# United States Department of the Interior

Re: Resource Recovery and Protection Plan (R2P2) Minor Modification, Longwall Mining System Installation.

# TOWER DIVISION ABERDEEN SEAM PRODUCTION AREAS LONGWALL PLAN

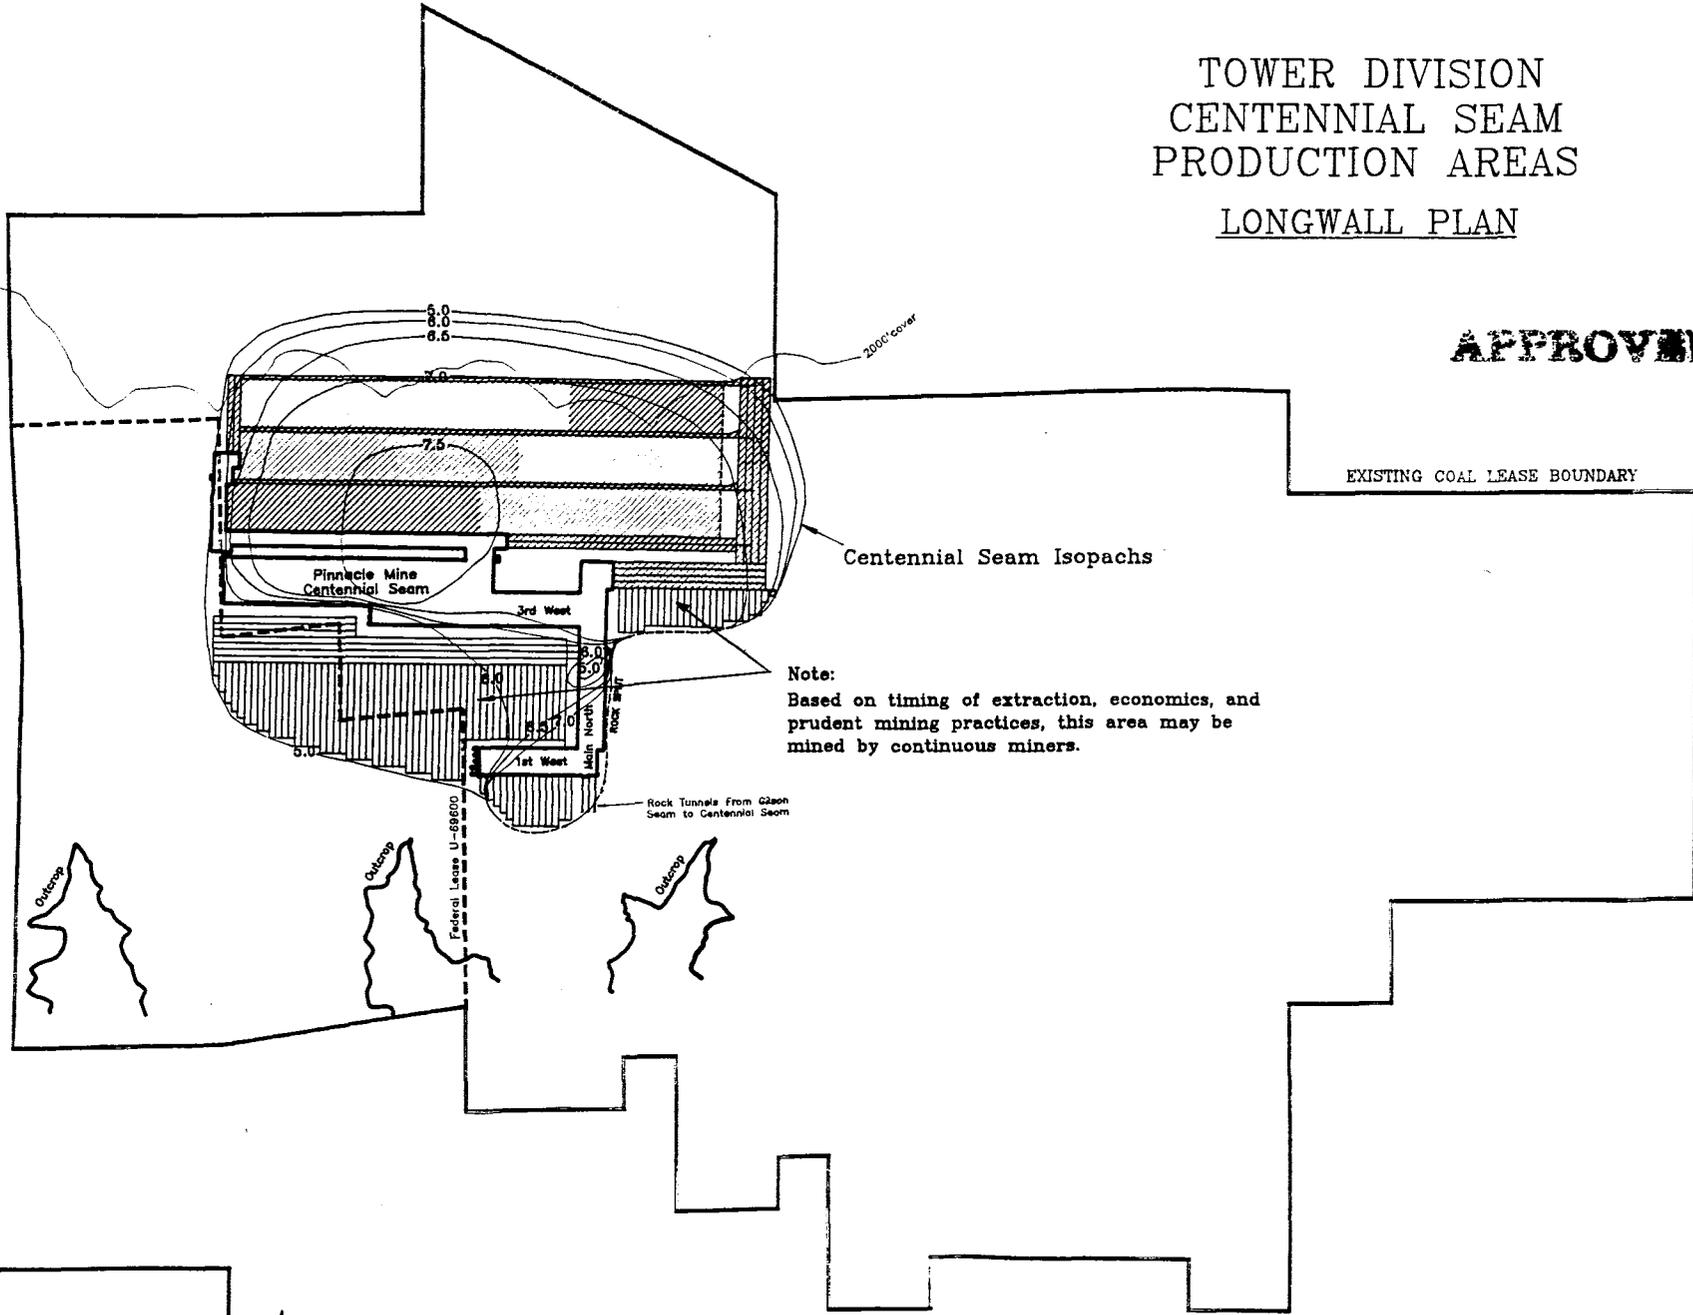
MINOR MODIFICATION TO  
MINING PLAN APPROVED BY  
BUREAU OF LAND MANAGEMENT
